SUNDRY NOTICES AND REPORTS ON WELLS (DO NOT USE THIS FORM FOR PROPOSALS TO DRILL OR TO DEEPEN OR PLUG BACK TO A DIFFERENT RESERVOIR. USE "APPLICATION FOR PERMIT" (FORM C-101) FOR SUCH PROPOSALS.)		WELL API NO. 30-015-32446

2. Name of Operator COG Operating LLC		6. State Oil & Gas Lease No. LG 0023-3
3. Address of Operator 600 W. Illinois, Midland, TX 79701		7. Lease Name or Unit Agreement Name Loving 1 State

Loving 1 State 3
API 30-015-32446
Lat 32.2487717
Long -104.1504974

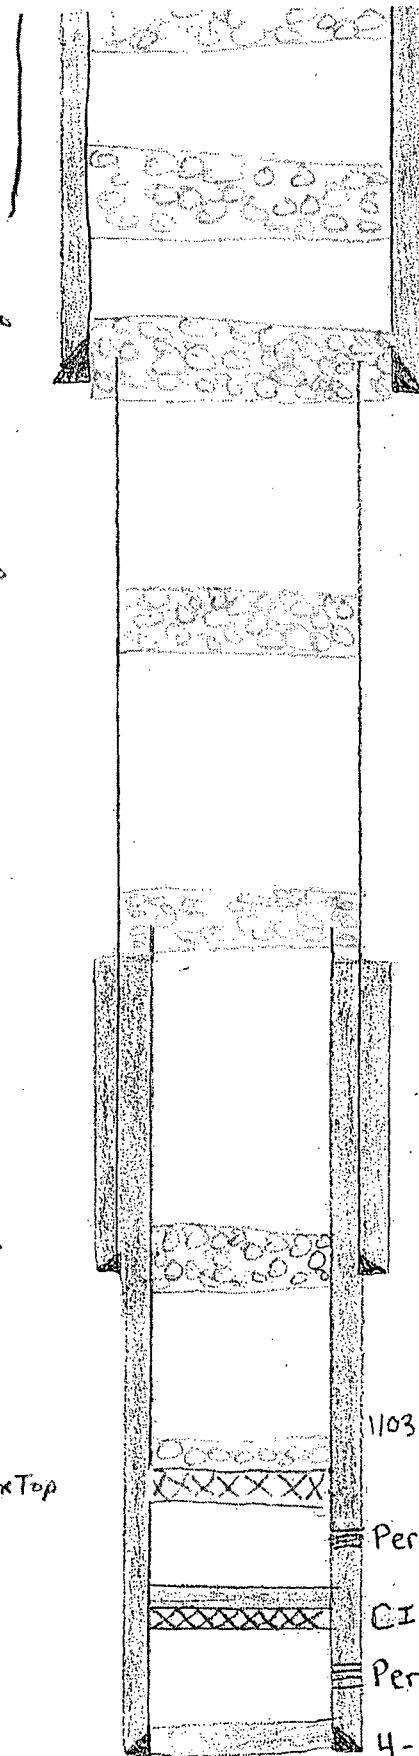
1. Produced water **will not** be used during any part of the plugging & abandonment operation.
2. Notify NMOCD Dist. 2 office at least 24 hrs before beginning work.

3. Closed Loop System is to be used for entire plugging operation. Upon completion, contents of steel pit are to be hauled to a permitted disposal location.

7. Every attempt must be made to clean the well bore out to below the perfs, before any plugs can be set, by whatever means possible.
8. Cement Retainers may not be used.

9. Squeeze pressures are not to exceed 500 PSI, unless approval is given by NMOCD.
10. Plugs may be combined after consulting with and getting approval from NMOCD.

11. Minimum WOC time for tag plugs will be 4 Hrs.
